NISSEI CORPORATION
Sales Planning Dept.

Change notification for Single Phase Capacitor

■ Dimension comparison

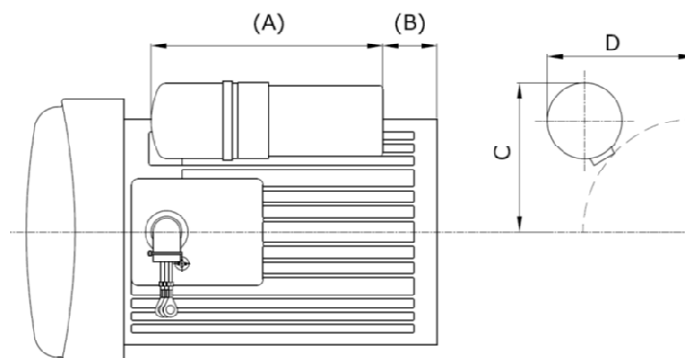
A	B	C	D
Current Capacitor	95	43	76	76
New Capacitor	113	30	78	78
